PROJECT BRIEF

Historic District Board of Review Application for Certificate of Appropriateness at 718 W. Main St. to add window on rear second story of home in new bathroom; window will be same size, shape, design as other window on same wall.

Application Date: March 29, 2023
HDBR Meeting Date: April 24, 2023

Layout 4

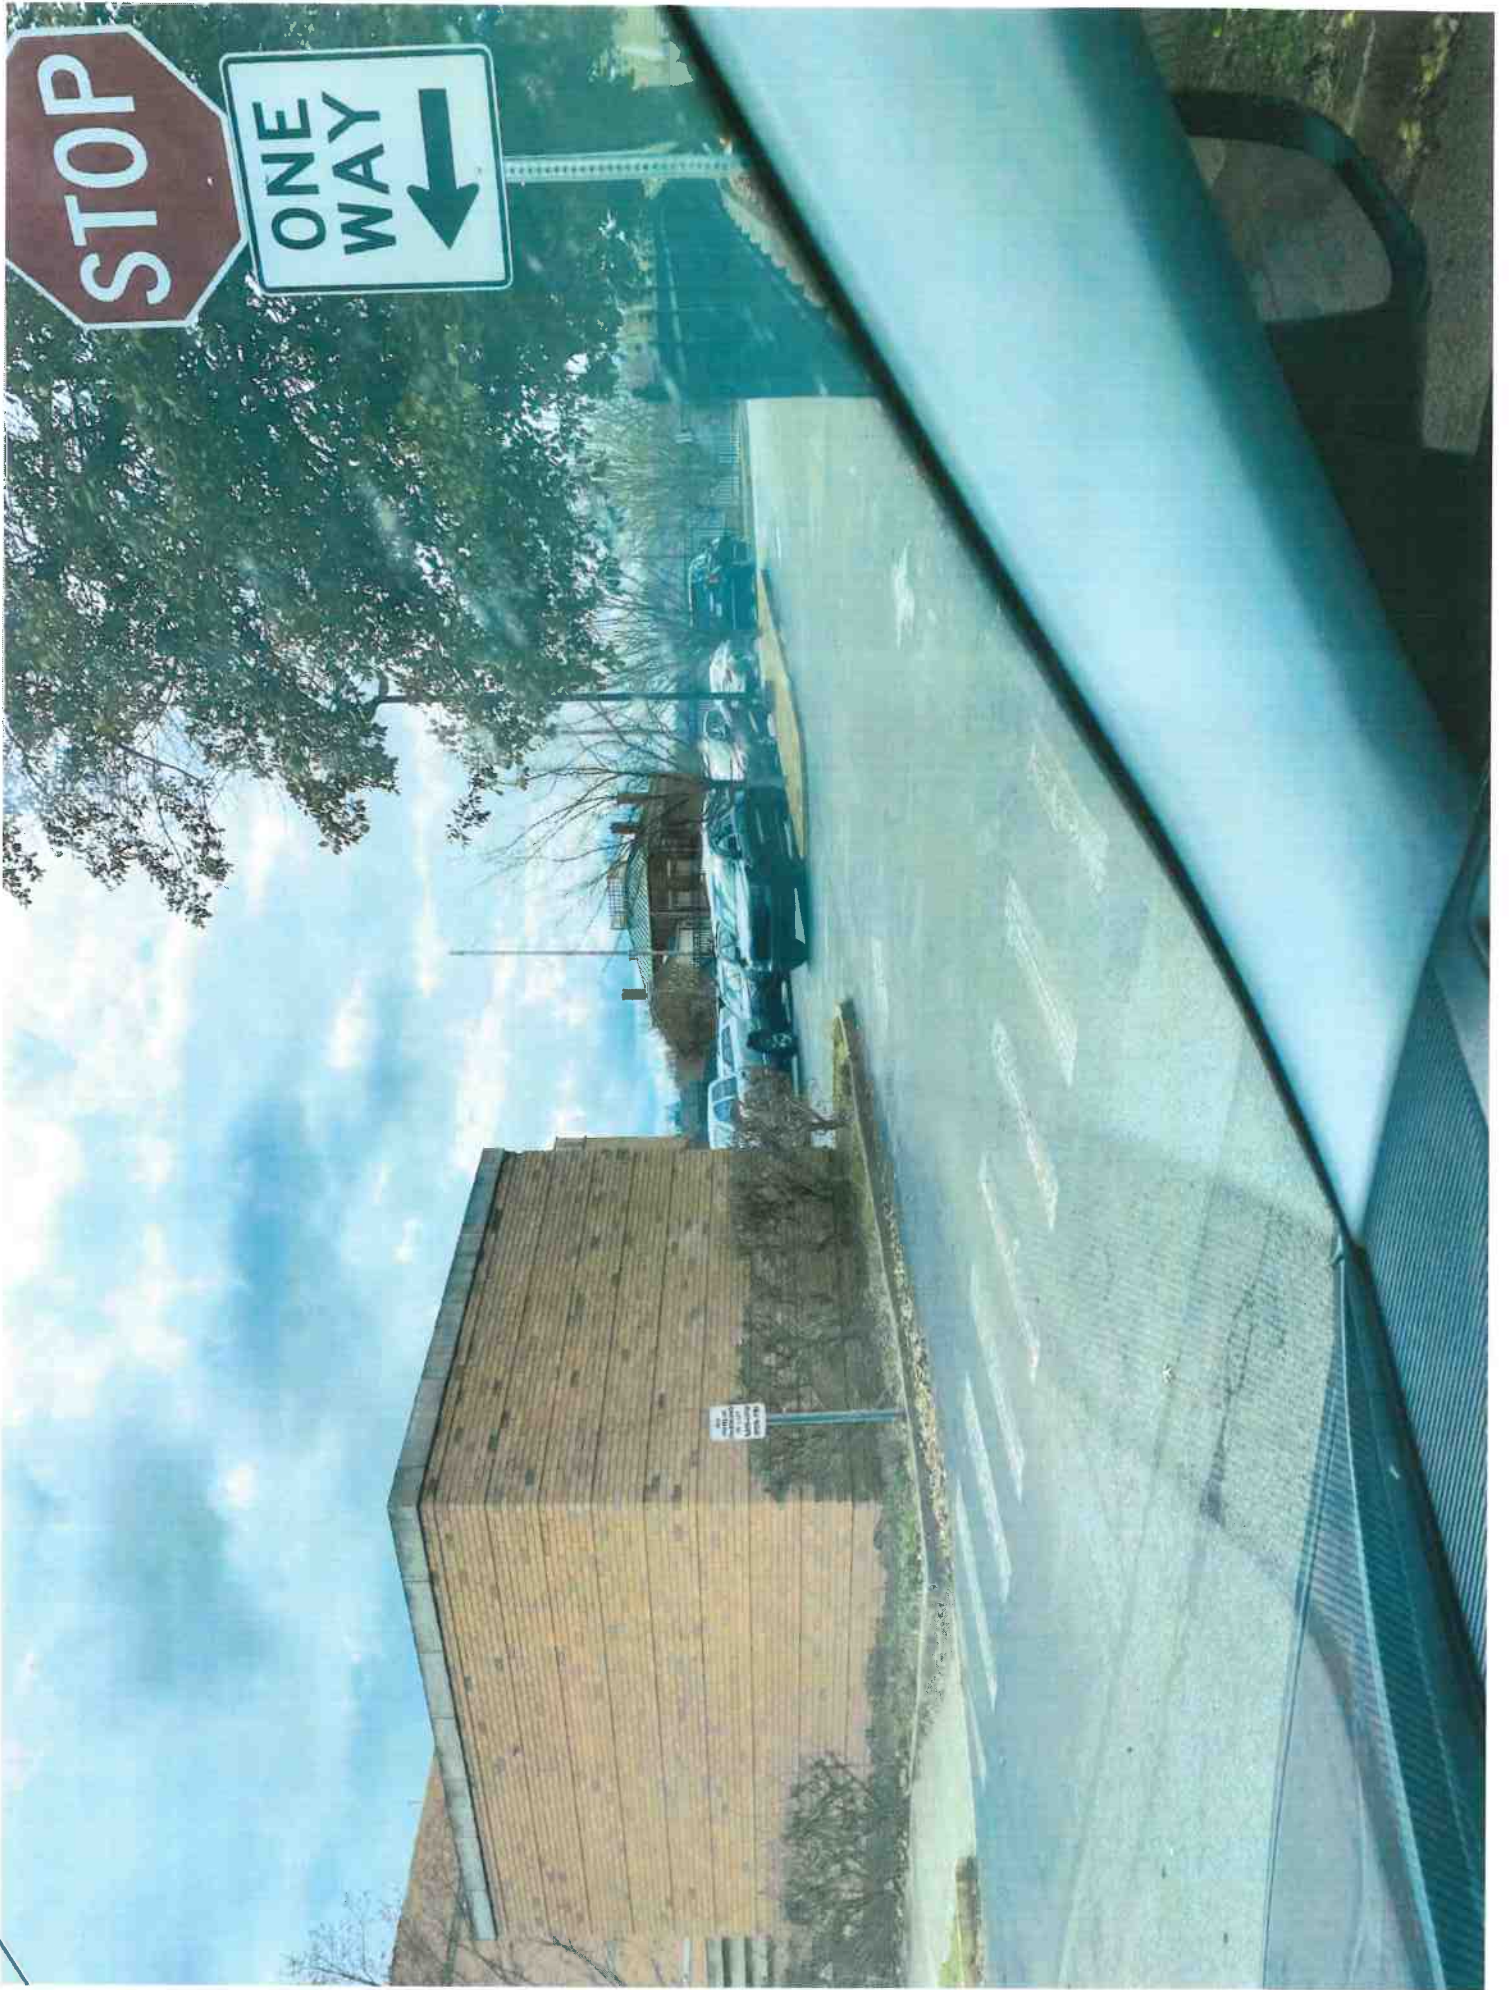
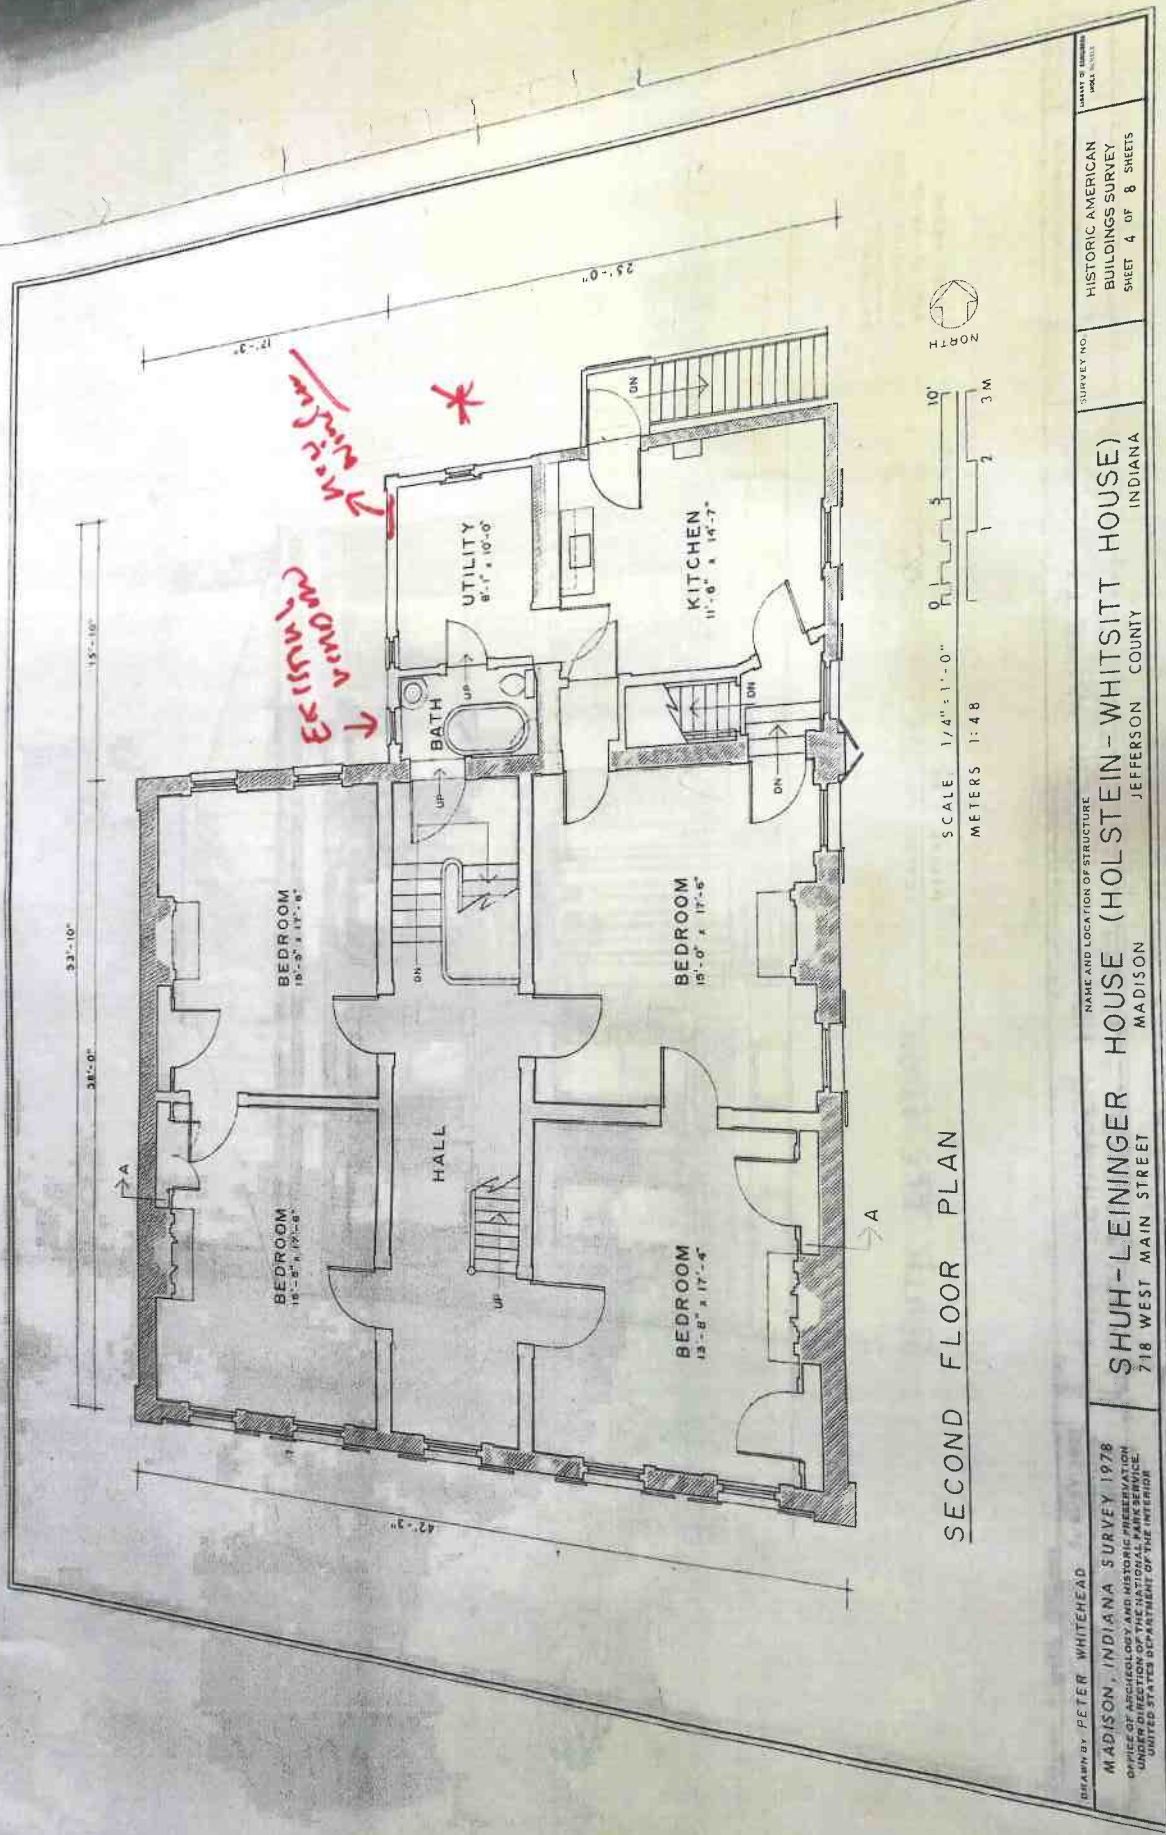
* THIS IS AN OLD PLAN BEFORE PREVIOUS OWNER RENOVATIONS.

* WE ARE TAKING HOUSE BACK TO ORIGINAL
